Development Department

RE: Waterford Square 2nd Filing Final Plat Recommendation

A REPLAT OF LOTS 2 THRU 19
AND LOTS 21 THRU 57, BLOCK 8,
WATERFORD SQUARE,
CITY OF CHEYENNE,
LARAMEE COUNTY, WYOMING.
PREPARED JULY, 2016

WATERFORD SQUARE 2ND FLOOR

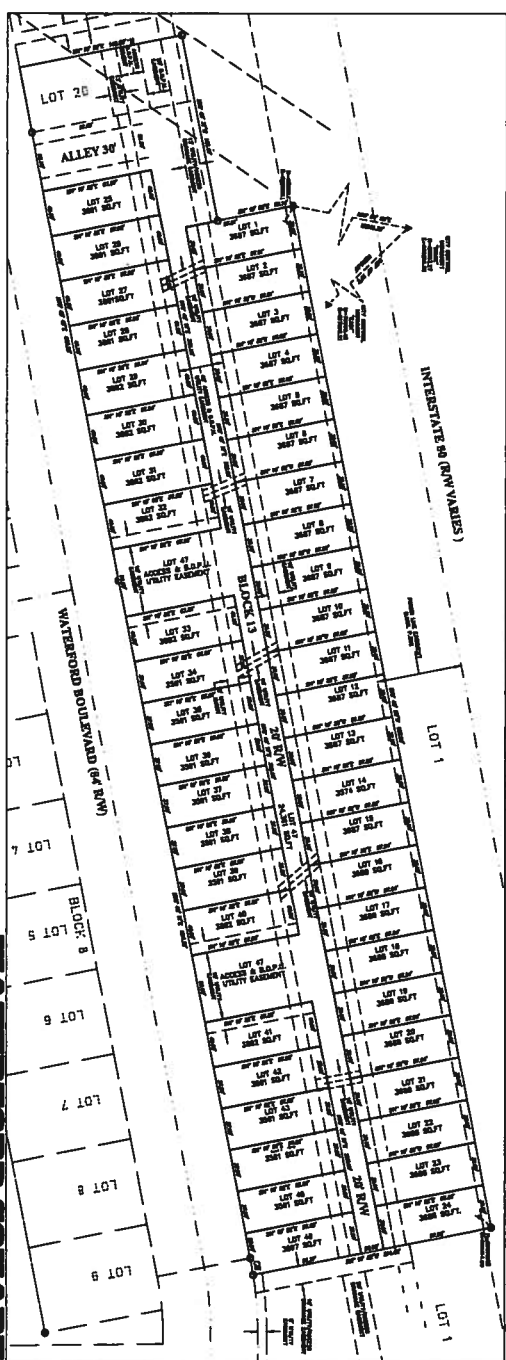
The original Waterford Square plat proposed 4-plex buildings with a shared public parking area in the middle with a 26' wide drive aisle. This plat proposes reducing the density by half and placing the parking on private lots. A 20' wide drive aisle (or accessway) remains. The plat proposes parcels which are located between the accessway and I-80. In order for these parcels to be effectively serviced by emergency response agencies, the accessway will be **required** to be named by Fire Code. If the development had remained as 4-plexes, the drive aisle of the parking lot would still have been required to be named. For apartment-style development, the City does allow named parking lot drive aisles (see the Carter Cottage plat development).

The applicant proposes that the accessway will be maintained by an HOA. If the accessway is built as proposed, the City is concerned that if the HOA fails, and if the City is required to take over maintenance of the accessway, and if the accessway has a name, those living off the accessway may expect street-level maintenance of what is effectively an alley.

Staff maintains that by naming an accessway, it will be considered a private street. Private streets are **not** allowed per section 4.3.2.c of the Unified Development Code, except *"in some extraordinary cases where there is no public right-of-way, and no feasible means of access to public right-of-way, it may be necessary for property owners to provide access by means of easements or other agreements and to construct a private access road."* As private streets are not allowed, this accessway will be required to be built to a City street standard. The narrowest City street is 50' wide. The current accessway is proposed at 20' wide (the 20' wide access is proposed on the revised map).

The product the developer wishes to place on these lots will not be able to be placed once the necessary 30' is added. As staff requires a street section to replace the proposed accessway, and the proposed development does not have enough room for the street and the proposed product to be built, staff recommends denial of this plat.
